RE: New Territories POADP #187

The Development Review Committee has reviewed and accepted your proposed plan for New Territories. The plan has been assigned File #187 for future reference.

RE: New Territories P.O.A.D.P. (Revised August 26, 1985)
(File #83-10-61-60)

Re: New Territories Preliminary Plan
 P.O.A.D.P. revision
 File #: 85-10-61-60 dated Feb 26, 1985

MASTER PLAN

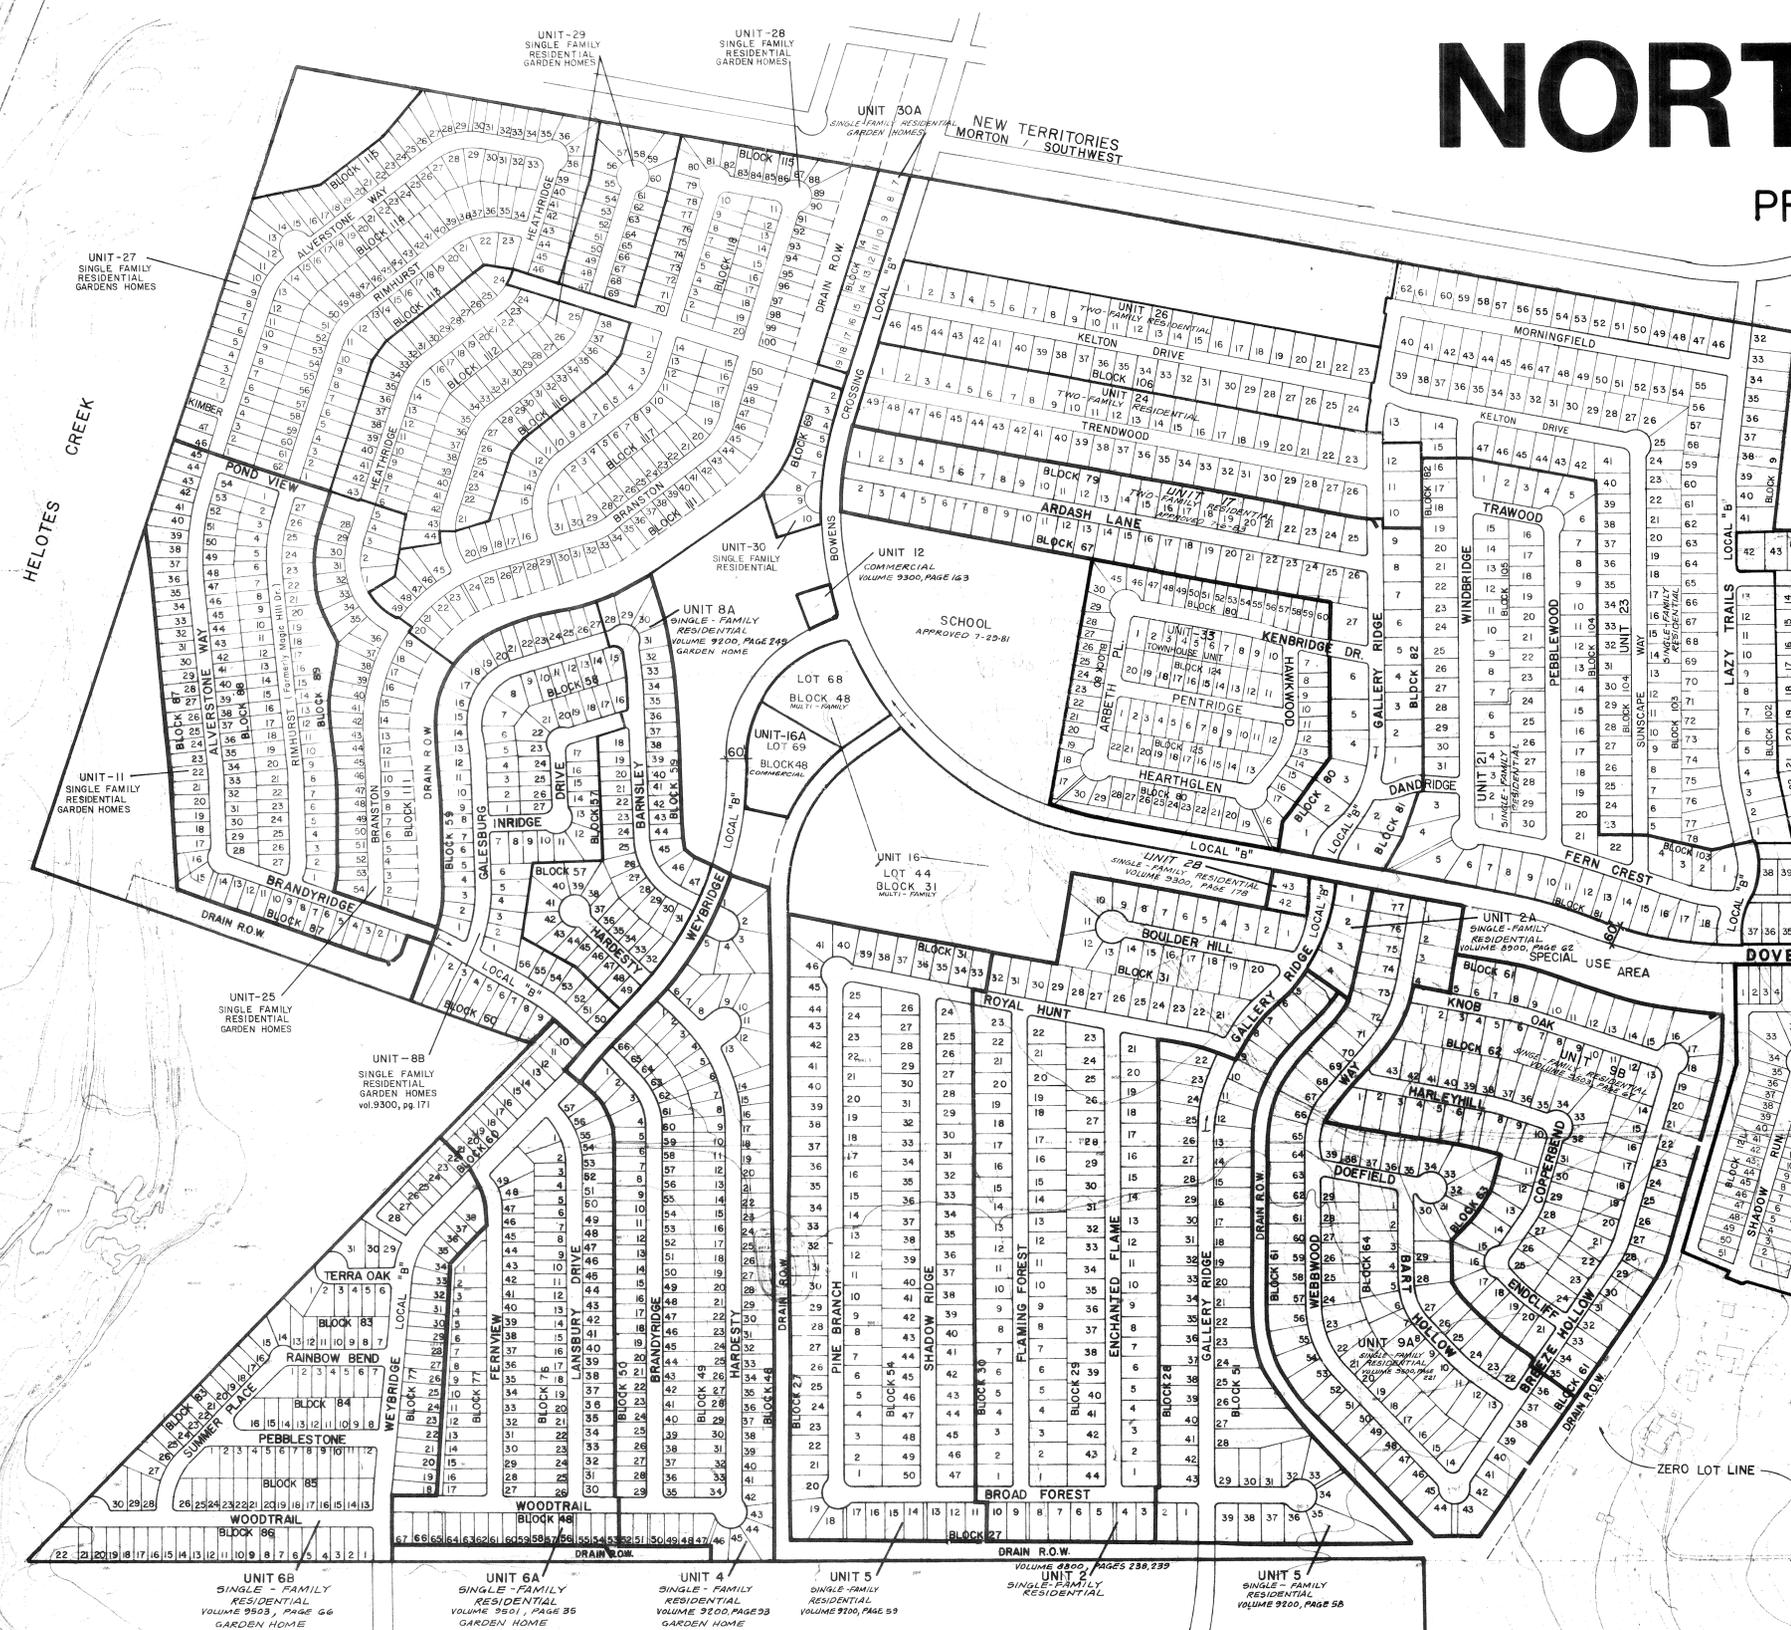
It is noted that the removal of April Bend Drive leaves an undesirable stub street in New Territories Subdivision Unit-24. Staff recommends that if the stub street has not been constructed, the stub street be removed and designated as an easement. Please coordinate this effort with the Traffic and Transportation Section of the Department of Public Works.

The revised plan shows the addition of a 60' R.O.W. known as Brickwood between the Old Tezel Road and Guilbeau Road which is acceptable to the committee. The committee also acknowledges the 20' dedication proposed along Guilbeau Road.

Comments: This acknowledges receipt of the amended plan reflecting an annotation pertaining to the April Bend stub street as per our meeting of February 22, 1985. Please be advised that staff offers no objection to the revision.

In reference to your letter of December 7, we have again reviewed the revised POADP for New Territories. Staff still objects to the proposed stub-out of April Bend for two reasons:

1. It does not address the intent of our initial recommendation for a north-south collector; and
2. The approved POADP for Guilbeau Park does not reflect a corresponding street connection.

The intent of our initial recommendation was to provide for a direct and continuous traffic flow to New Guilbeau Road via a realignment of Bowens Crossing. Traffic Engineering is of the opinion that April Bend does not provide a viable collector street alternative due to the number of turning movements required.

We recognize there is still a valid requirement for a collector connection to New Guilbeau Road. Based on our original recommendation and the development which has subsequently occurred, we see the only viable alternative as a realigned Bowens Crossing. This street should be upgraded to a collector north of Unit-8 and be realigned to merge with Laurel Bend to the northern boundary of your subdivision.

Our review has concluded that said plan is in general compliance with Chapter 36 of the City Code. Although the plan reflects a collector street (60' R.O.W.) paralleling F.M. 1604, City plat records reflect that said street has been platted as a 50' R.O.W. on Units 9 and 15. Given that these units have been approved by the Planning Commission, it is recommended that the 60' R.O.W. be provided on future plats as indicated on the plan. Said 60' R.O.W. should be platted from a point north of Unit-15 to the proposed intersecting collector which is planned to directly link with F.M. 1604.

Secondly, in addition to the north and south collector street platted with Units 8 and 3 which provide direct access to F.M. 1604, consideration should be given to providing a stub street to the north. The preferred alignment is to maintain the north and south alignment and continue it to the northern limits of the planned development. The stub being recommended should be provided from a point north of the northwesterly curvature which is shown on the plan. Essentially, the recommended proposal would accommodate a connection with the proposed alignment linking F.M. 1604 and Guilbeau Road as illustrated on the Major Thoroughfare Plan.

1. Paragraph two asked for provision of a 60' ROW (Grand Bend) as indicated on the plan----- we have two reasons for not complying with the request:
 - (a) Though the plan indicated a Local "B" street, the placement of Local "B" was inadvertently shown by us in an incorrect location. Our intent was to provide a Local "B" street for the first block length due to possible commercial/mult-family construction adjacent to this area.

- (b) Secondly, the revised street alignments per the current P.O.A.D.P. submittal changes the scope of this area. Again, we are considering the possibility of a larger area for commercial/multi-family use, and our intent, as indicated on the plan, is to provide a Local "B" street from Hoovers Bend north to the common property line between New Territories and Guilbeau Park Subdivision.

2. Paragraph three requested consideration of a street stub to the north extending from Bowens Crossing to Guilbeau Road ----- . Let me reiterate that all master plans are subject to change. Many changes have transpired since the original P.O.A.D.P. review. Guilbeau Park Subdivision has had a detrimental effect upon some of the planning for New Territories. One major change has been that of the closing of Guilbeau Road per the Commissioner's Court of Bexar County, Texas dated March 14, 1984. A new alignment for Guilbeau Road has been provided by the recorded plat of Guilbeau Park Subdivision, Unit 1, (Volume 9503, Page 190) which does not closely resemble the old alignment. The platting of Block 13, Guilbeau Park Subdivision, Unit 2 (Volume 9505, Pages 101-104) does not allow for a thru street if we were to provide the requested street stub.

3. Paragraph four: The intersection of Guilbeau Road with Tezel Road is the only location at which dedication will be required as set out by the major thoroughfare plan. The commercial tract shown on the P.O.A.D.P., when platted, will provide the appropriate dedication.
4. Reference is made to the downgrading of Hill Trails from a Local "B" to a 50' ROW north of the intersection of Charter Point. Originally, Hill Trails was to intersect Guilbeau Road. A combination of the deletion of the major thoroughfare at this location, and the present P.O.A.D.P. of Guilbeau Park Subdivision has extinguished the need for a Local "B" street. A copy of the revised Guilbeau Park Subdivision P.O.A.D.P. is attached noting concurrence between the firms of Macina, Bose, Copeland and Associates, Inc. and Pape-Dawson Engineers.
